SUBJECT: Wake County, Davis Drive (SR 1613/SR 1999) from
Morrisville-Carpenter Road (SR 3014) in Wake County to
NC 54 in Durham County; T.I.P. Number U-4026; State
Project 9.8051713

SUBJECT: Action ID 2008-02065; TIP No. U-4026

Subject: Modification to the 401 Water Quality Certification Pursuant to Section 401 of the Federal Clean Water Act with ADDITIONAL CONDITIONS for Proposed widening of SR 1613/SR 1999 in Wake and Durham Counties, State Project No. 98051713, TIP No. U-4026, DWQ Project No. 20051972 ver.3

PERMIT SITE 4
PLAN VIEW

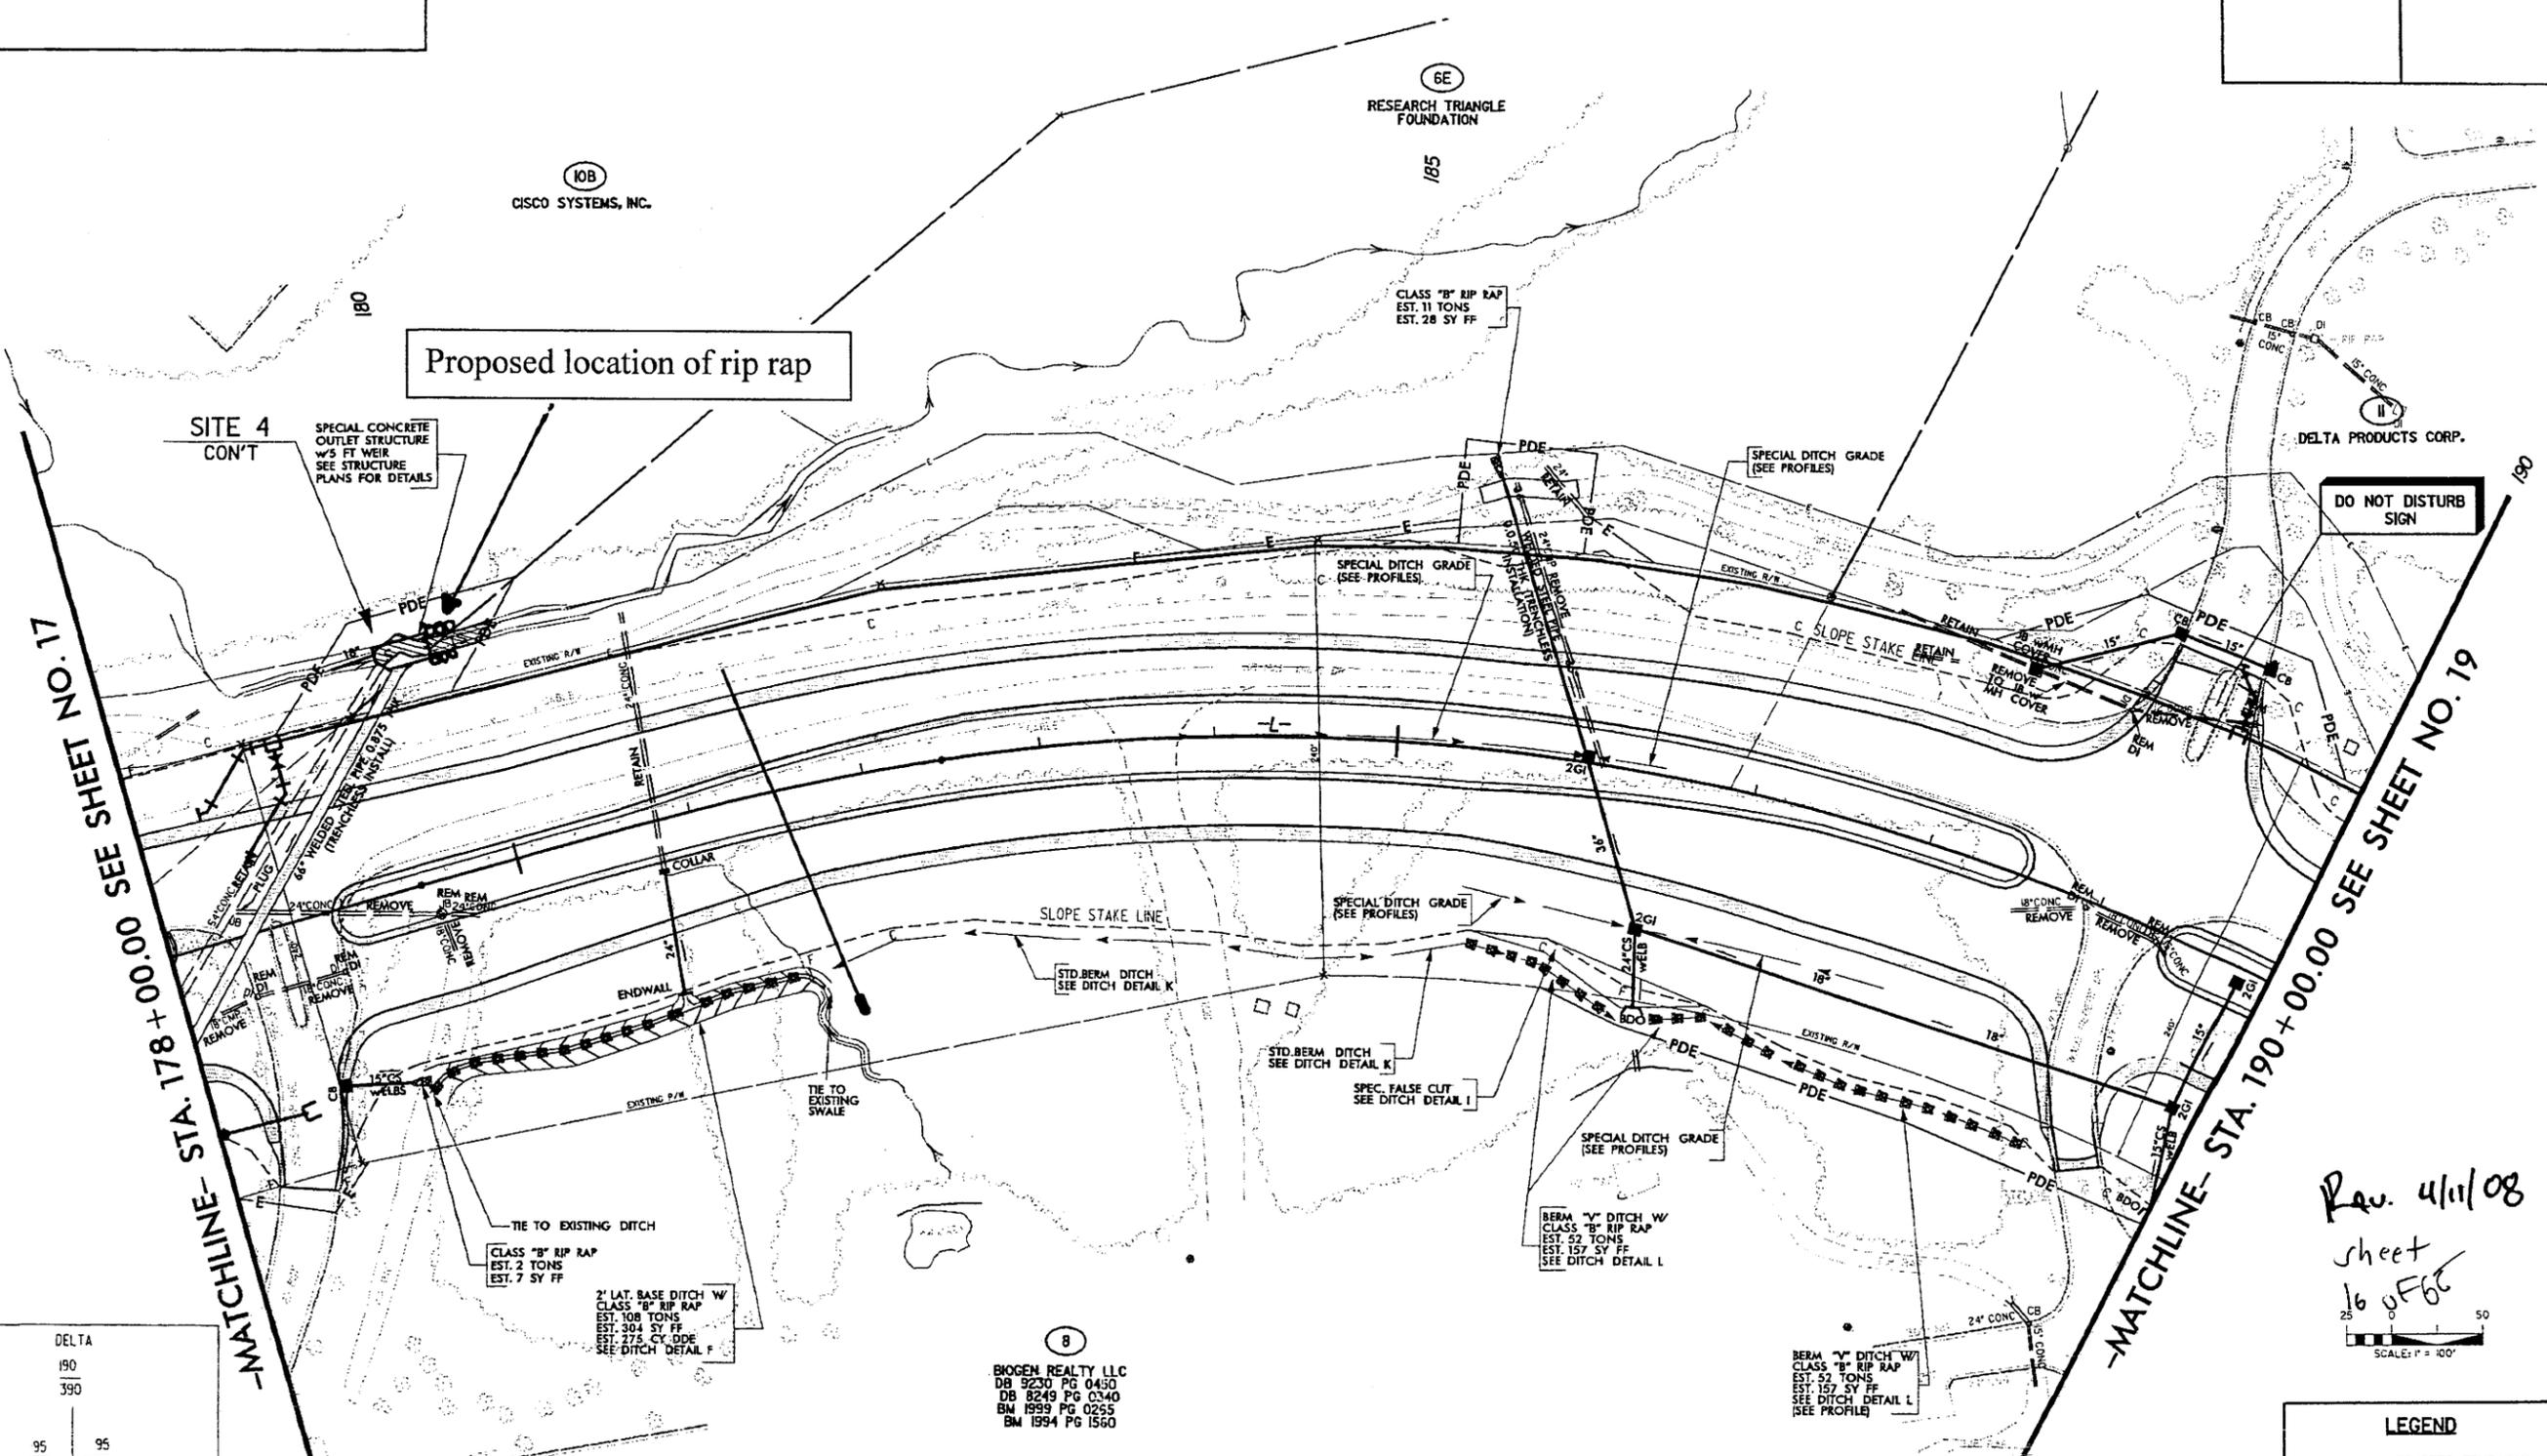
THIS CERTIFICATION is issued in conformity with the requirements of Section 401 Public Laws 92-500 and 95-217 of the United States and subject to the North Carolina Division of Water Quality (DWQ) Regulations in 15 NCAC 2H .0500. This certification modifications authorizes the NCDOT to impact an additional 15 linear feet of jurisdictional streams Wake and Durham Counties. The project shall be constructed pursuant to the modification dated received May 20, 2008. The additional authorized impacts are as described below:

Site	Rip Rap to Perennial Stream (linear ft)	Total Stream Impact (linear ft)
4	15	15
Total	15	15

1. All other conditions written into previous Water Quality Certifications and modifications for this project still apply.
2. The use of rip-rap above the Normal High Water Mark shall be minimized. Any rip-rap placed for stream stabilization shall be placed in stream channels in such a manner that it does not impede aquatic life passage.

PERMIT SITE 7
PLAN VIEW

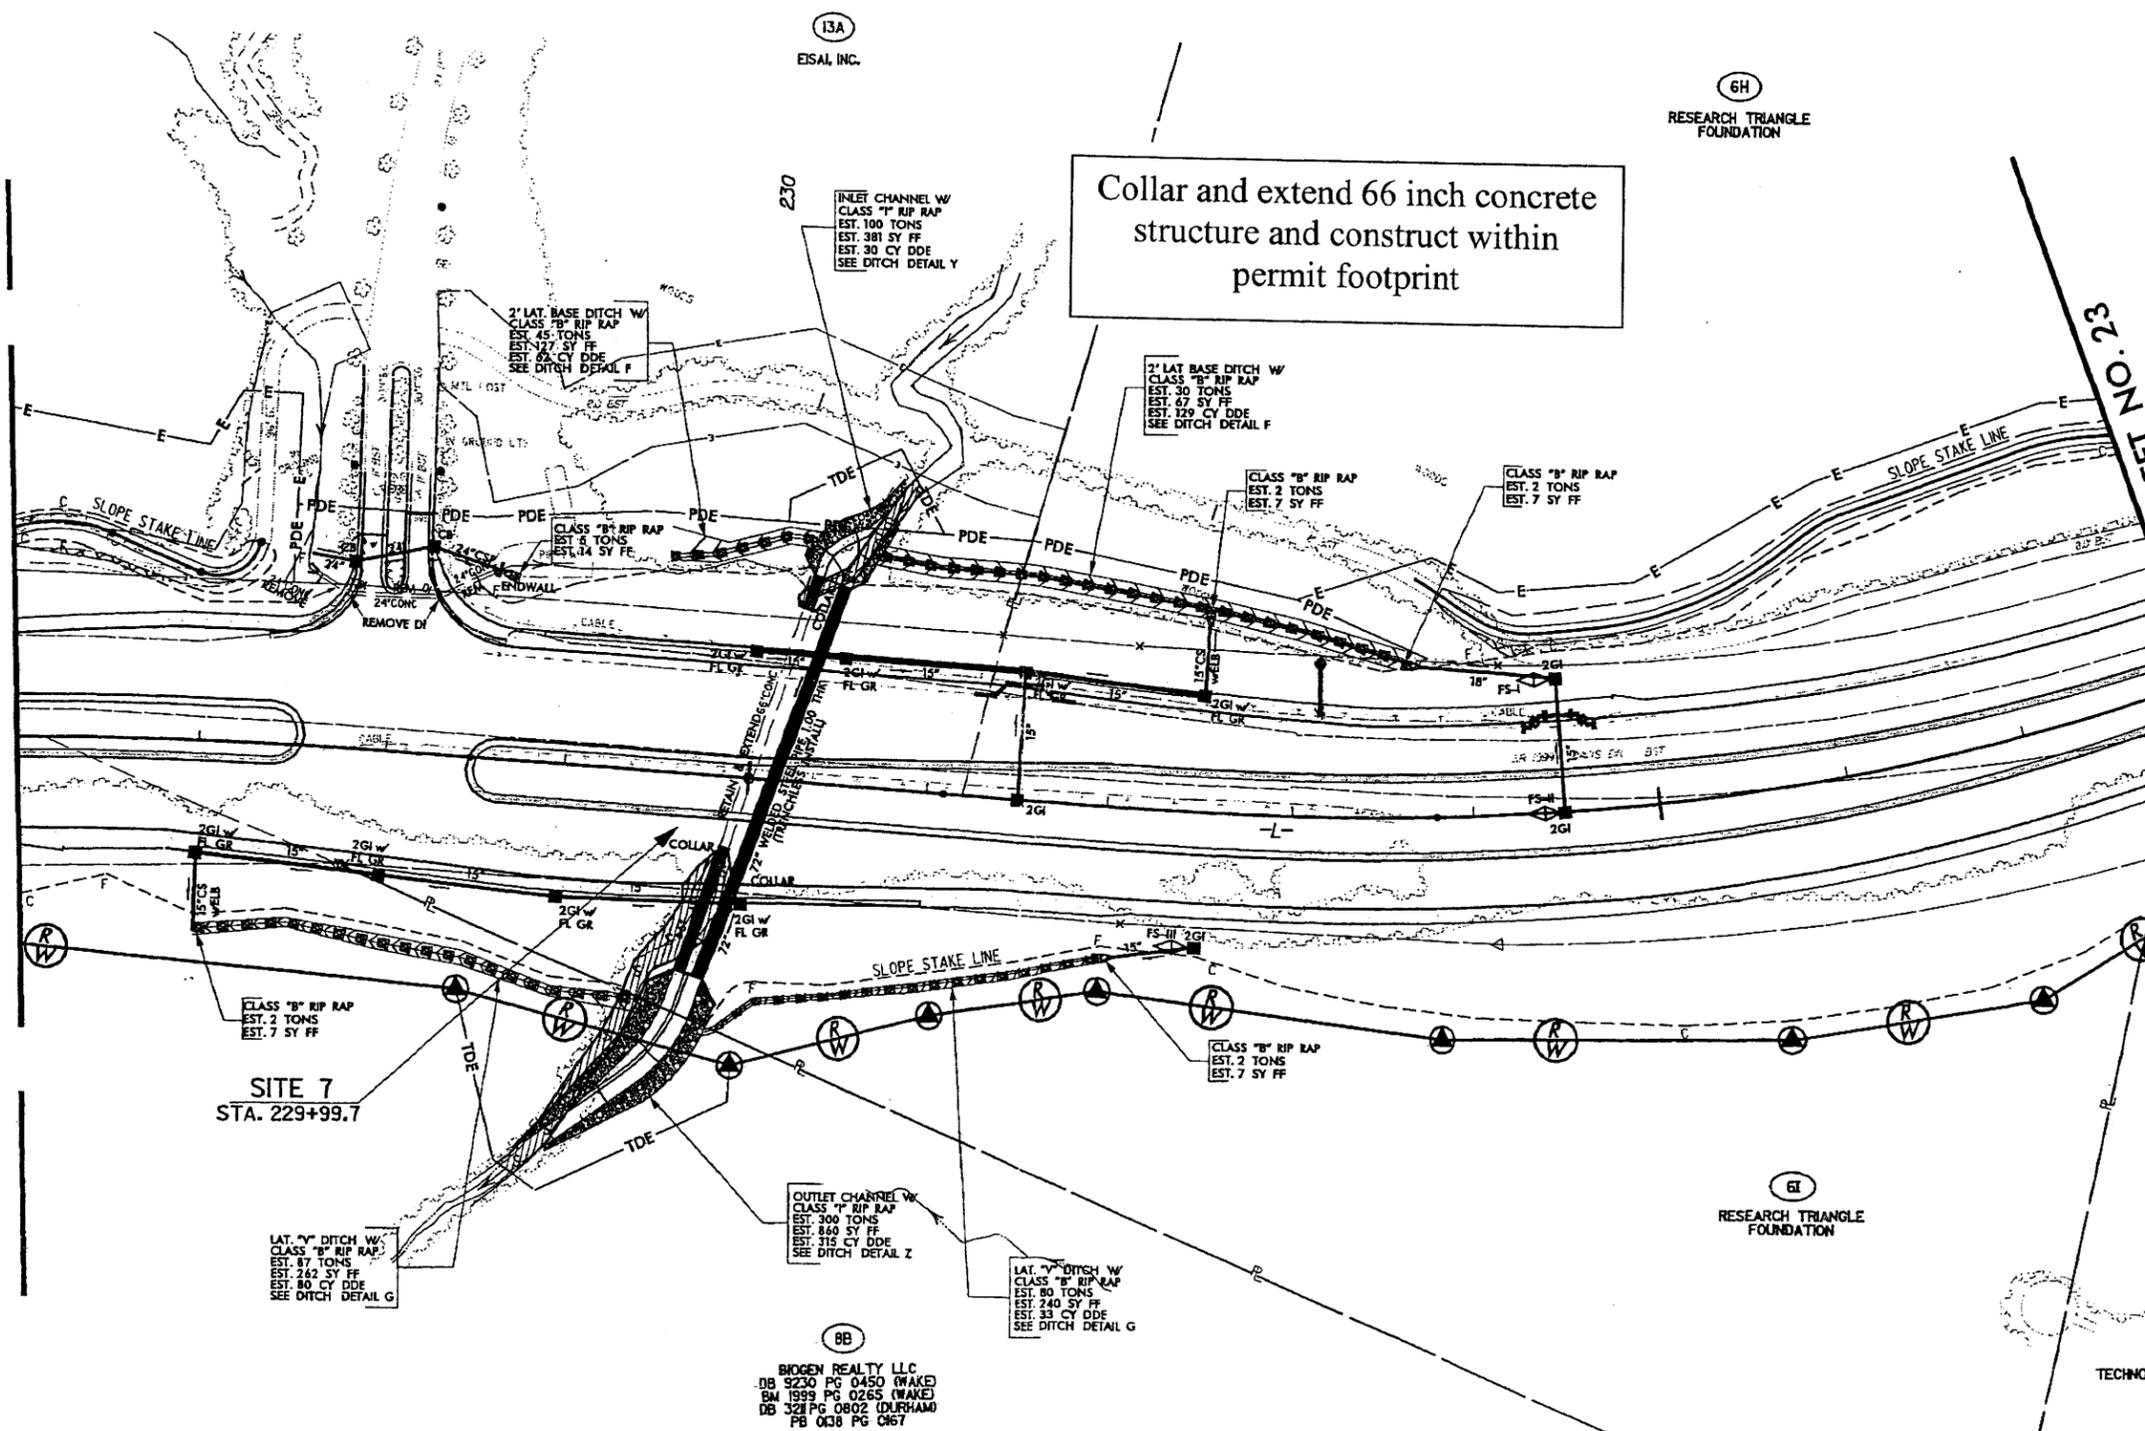
Collar and extend 66 inch concrete structure and construct within permit footprint

PERMIT SITE 9
PLAN VIEW

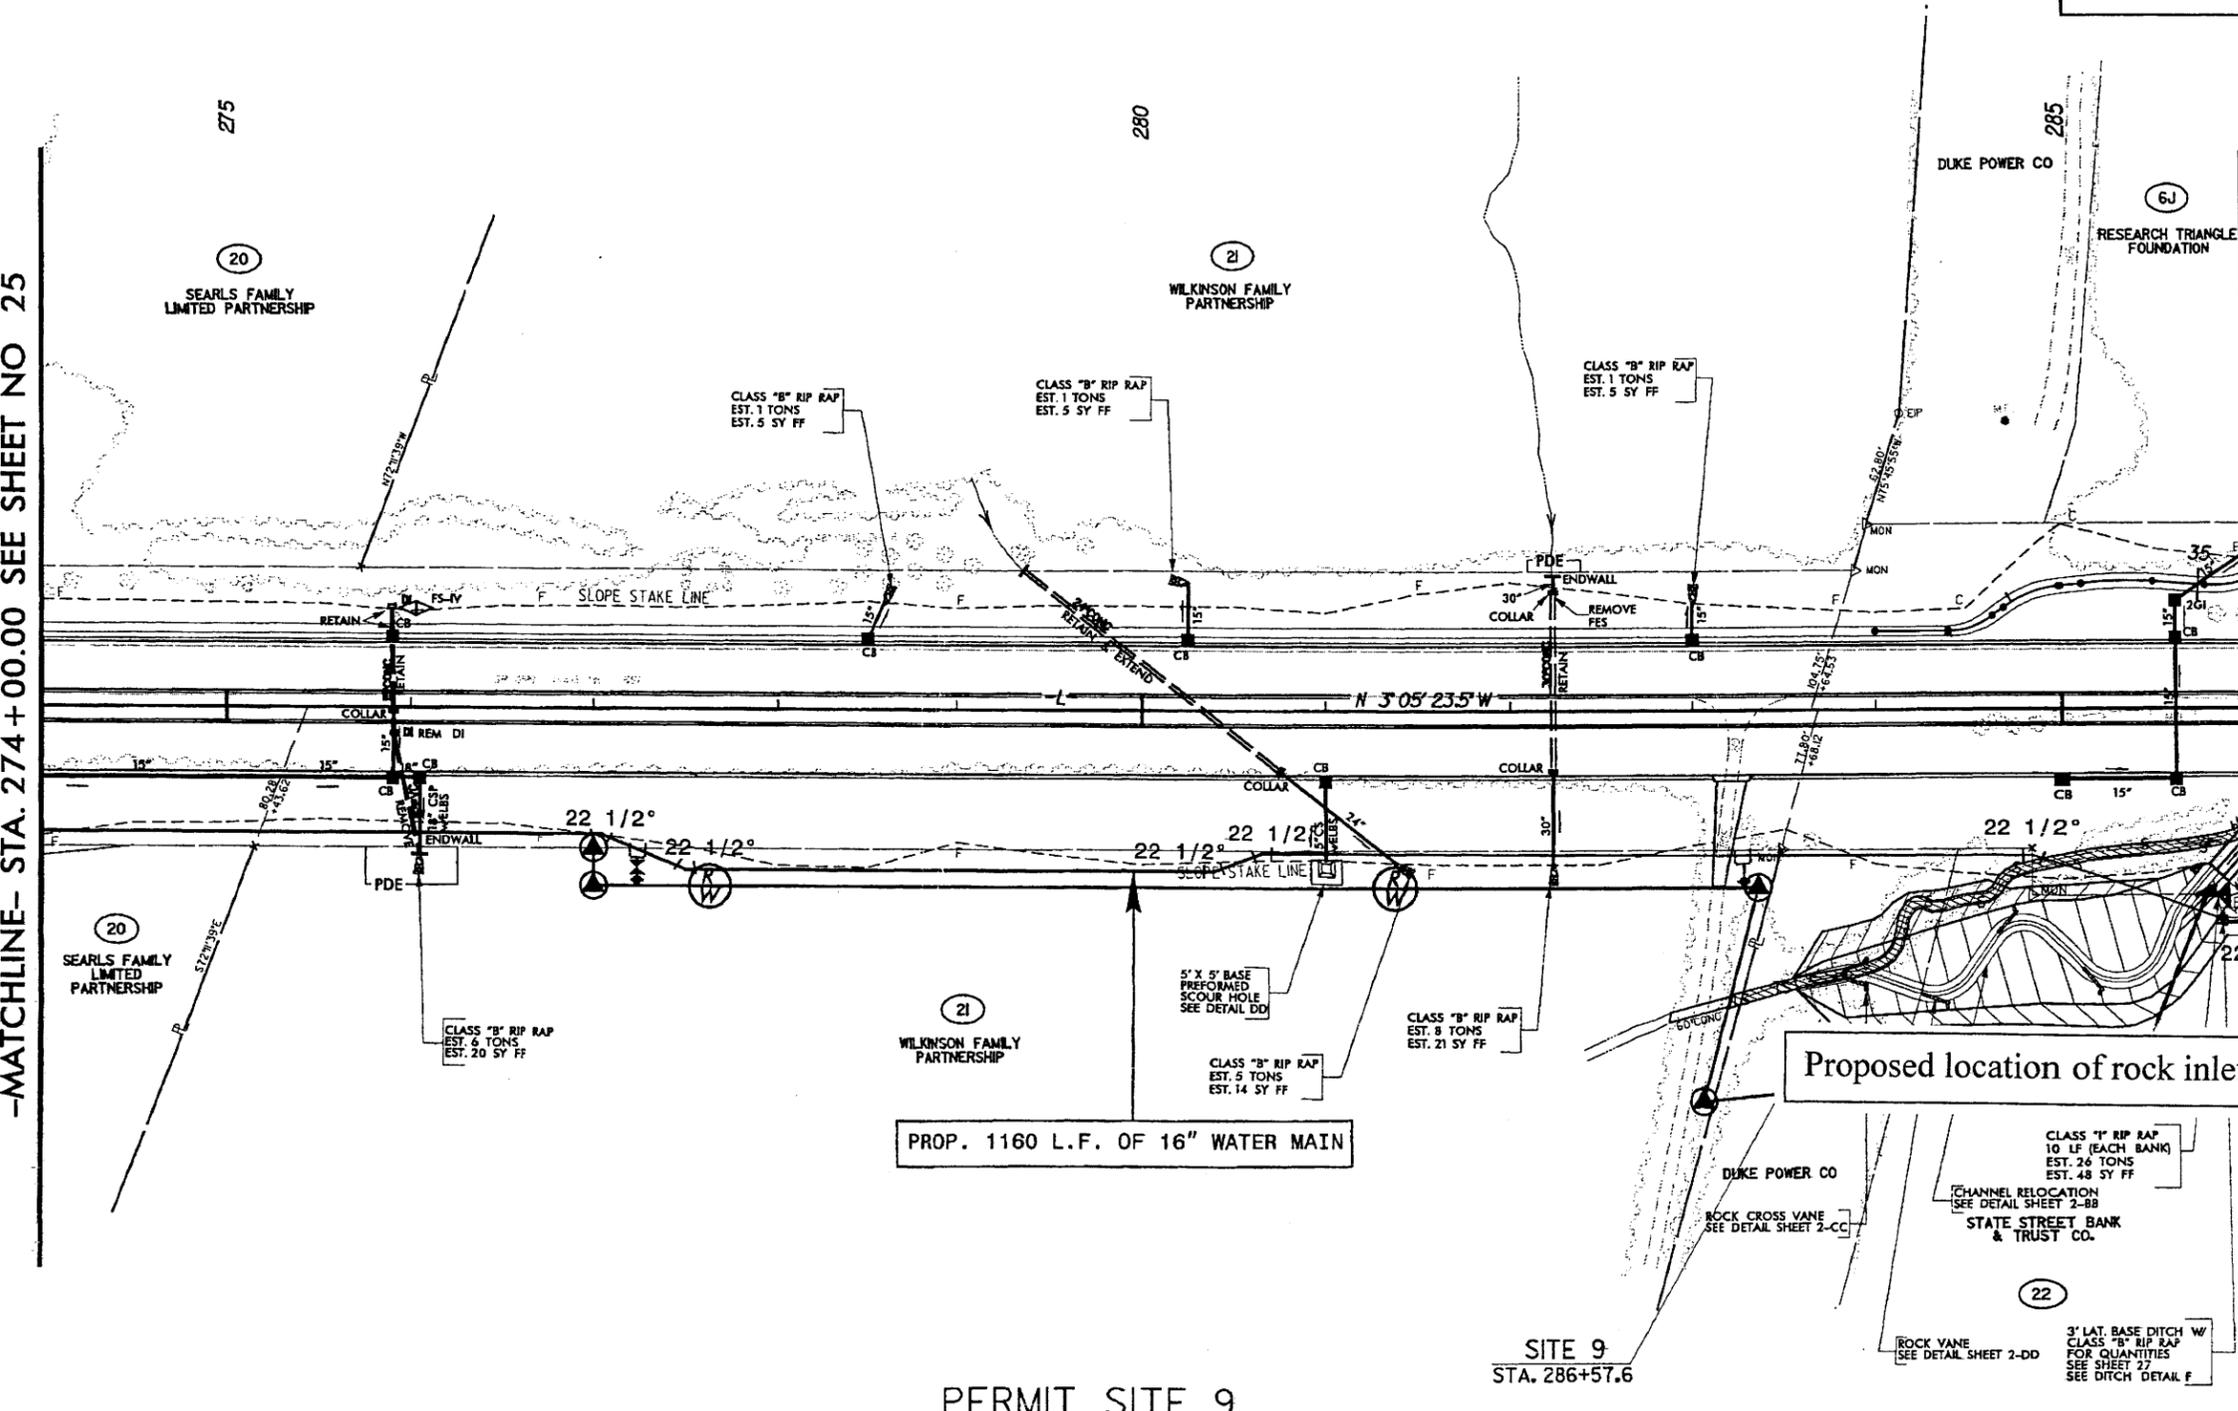
The design plans denote this area as Site 9. The plans include stream relocation and mitigation per the original commitment.

Proposed location of rock inlet sill
